Note Proposed Amendments: (added text to the code is: underlined, deleted text to the code is: ~~struck through~~)

ITEM	SECTION	SUMMARY	PROPONENT	ACTION
2018-01	PREFACE Part IV Chapter 11	Part IV, Energy Conservation (Chapter 11) is deleted from the INTERNATIONAL RESIDENTIAL CODE FOR ONE- AND TWO-FAMILY DWELLINGS. Substitute all references to Chapter 11 ENERGY EFFICIENCY with references to the <i>Georgia State Minimum Standard Energy Code (International Energy Conservation Code with Georgia State Supplements and Amendments)</i> .	Task Force (Team 1)	A (CF)
2018-02	PREFACE Part VII	Part VII, Plumbing (Chapters 25 through 33), is deleted from the INTERNATIONAL RESIDENTIAL CODE FOR ONE- AND TWO-FAMILY DWELLINGS. Substitute for plumbing requirements the <i>Georgia State Minimum Standard Plumbing Code (International Plumbing Code with Georgia State Amendments)</i> .	Task Force (Team 1)	A (CF)
2018-03	PREFACE Part VIII	Part VIII, Electrical (Chapters 34 through 43) is deleted from the INTERNATIONAL RESIDENTIAL CODE FOR ONE- AND TWO-FAMILY DWELLINGS. Substitute for electrical requirements the <i>Georgia State Minimum Standard Electrical Code (National Electrical Code with Georgia State A

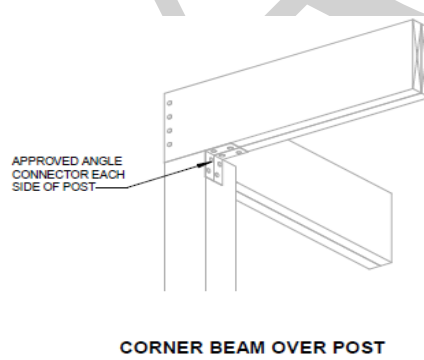
ITEM	SECTION	SUMMARY	PROPONENT	ACTION										
2018-15	Table R302.6	<p>Revise Table R302.6 ‘DWELLING-GARAGE SEPARATION’ to add a new footnote “a” under the column ‘SEPARATION’ for ‘Structures(s) supporting floor/ceiling assemblies used for separation required by this section’ as follows:</p> <p style="text-align: center;">TABLE R302.6 DWELLING-GARAGE SEPARATION</p>

<table><tr> <th>SEPARATION</th> <th>MATERIAL</th> </tr><tr> <td>Structure(s) supporting floor/ceiling assemblies used for separation required by this section^a</td> <td>Not less than 1/2-inch gypsum board or equivalent</td> </tr></table>

<p>For SI: 1 inch = 25.4 mm, 1 foot = 304.8 mm. a. Separation of floor/ceiling assemblies is not required in garages protected by an automatic sprinkler system that meets the following criteria:</p> <ol style="list-style-type: none"> 1. <u>The sprinkler system shall be connected to a reliable water supply system with or without an automatic operated pump.</u> 2. <u>A piping system serving both sprinkler and domestic needs shall be acceptable.</u> 3. <u>Ordinary-temperature-rated residential or quick response sprinklers (135°F to 170°F [57°C to 77°C]) with a 1/2-inch (13 mm) orifice shall be installed.</u> 4. <u>The minimum operating pressure of any residential or quick response sprinkler shall be 7 psi (0.5 bar).</u> 5. <u>Walls that resist the passage of smoke shall separate the sprinklered compartment from any other space(s). Openings in this wall shall be regulated by Section R302.5.</u> 6. <u>The maximum area protected by a single sprinkler head shall not exceed 144 ft² (13.4 m²).</u> 7. <u>The maximum distance between sprinklers shall not exceed 12 feet (3.7 m).</u> 8. <u>The maximum distance to a wall or partition shall not exceed 6 feet (1.8 m).</u> 9. <u>The minimum distance between sprinklers within a compartment shall be 8 feet (2.4 m).</u> 10. <u>Pendent and upright sprinkler heads shall be positioned so that the deflectors are within 1 to 4 inches (25.4 to 102 mm) below framing.</u> 11. <u>Sprinkler heads shall be located on a looped piping configuration.</u> 12. <u>Minimum pipe size, including that for copper, listed chlorinated polyvinyl chloride (CPVC), and polybutylene (PB) piping shall be 3/4-inch (19 mm).</u> 13. <u>Garage doors in the open position shall not interfere with the operation of a sprinkler head.</u> 14. <u>A smoke alarm detector shall be installed in accordance with Section R314.</u> 	SEPARATION	MATERIAL	From the residence and attics	Not less than 1/2-inch gypsum board or equivalent applied to the garage side	From habitable rooms above the garage	Not less than 5/8-inch Type X gypsum board or equivalent	Structure(s) supporting floor/ceiling assemblies used for separation required by this section ^a	Not less than 1/2-inch gypsum board or equivalent	Garages located less than 3 feet from a dwelling unit on the same lot	Not less than 1/2-inch gypsum board or equivalent applied to the interior side of exterior walls that are within this area	Task Force (Team 1)	A (CF)
SEPARATION	MATERIAL													
From the residence and attics	Not less than 1/2-inch gypsum board or equivalent applied to the garage side													
From habitable rooms above the garage	Not less than 5/8-inch Type X gypsum board or equivalent													
Structure(s) supporting floor/ceiling assemblies used for separation required by this section ^a	Not less than 1/2-inch gypsum board or equivalent													
Garages located less than 3 feet from a dwelling unit on the same lot	Not less than 1/2-inch gypsum board or equivalent applied to the interior side of exterior walls that are within this area													
2018-16	R302.13	Delete Section R302.13 ‘Fire protection of floors’ without substitution.	Task Force (Team 1)	A (CF)

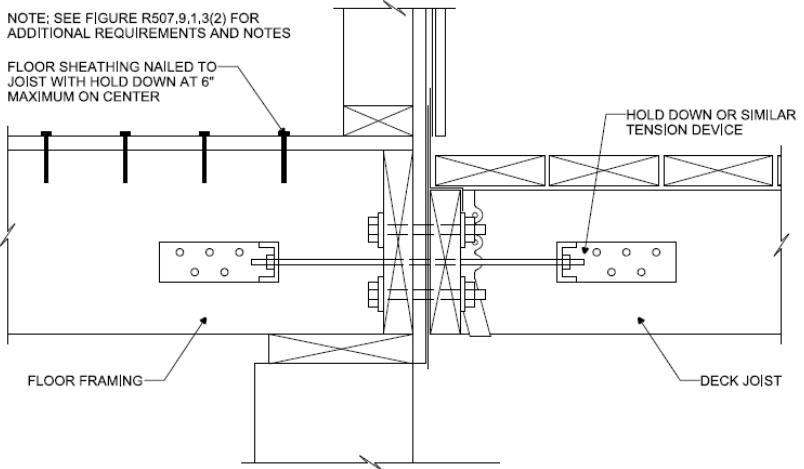
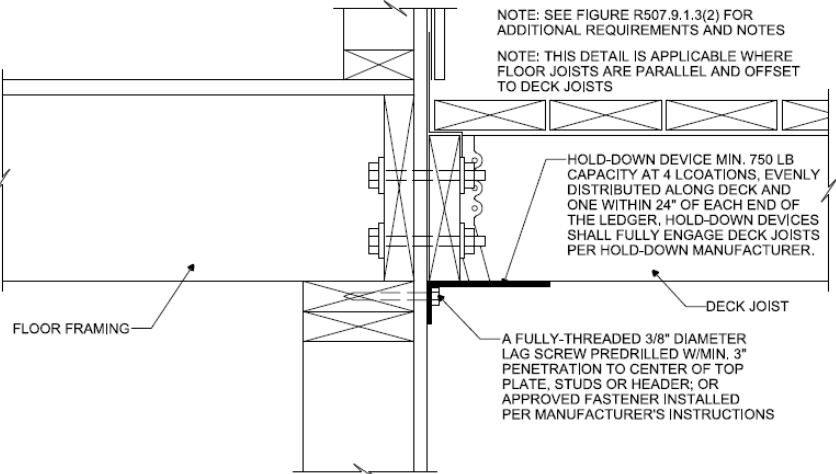
2018-27	R502.6	Revise Section R502.6 ‘Bearing’ to read as follows: R502.6 Bearing. The ends of each joist, beam or girder shall have not less than 1 1/2 inches (38 mm) of bearing on wood or metal, have not less than 3 inches of bearing (76 mm) on masonry or concrete or be supported by <i>approved</i> joist hangers. Alternatively, the ends of joists shall be supported on a 1-inch by 4-inch (25 mm by 102 mm) ribbon strip and shall be nailed to the adjacent stud. The bearing on masonry or concrete shall be direct, or a sill plate of 2-inch minimum (51mm) nominal thickness shall be provided under the joist, beam or girder. The sill plate shall provide a minimum nominal bearing area of 48 square inches (30 865 mm²).	Task Force (Team 2)	A
2018-28	R507.5.1(1)	Revise Figure R507.5.1(1) ‘DECK BEAM TO DECK POST’ to include a new illustration for “Corner Beam Over Post” as follows: 	Tim Williams	A
2018-29	R507.9.1.3	Revise R507.9.1.3 ‘Ledger to band joist details’ to read as follows: R507.9.1.3 Ledger to band joist details. Fasteners used in deck ledger connections in accordance with Table R507.9.1.3(1) shall be hot-dipped galvanized, or stainless steel, <u>or other approved fasteners</u> and shall be installed in accordance with Table R507.9.1.3(2) and Figures R507.9.1.3(1) and R507.9.1.3(2).	Tim Williams	A
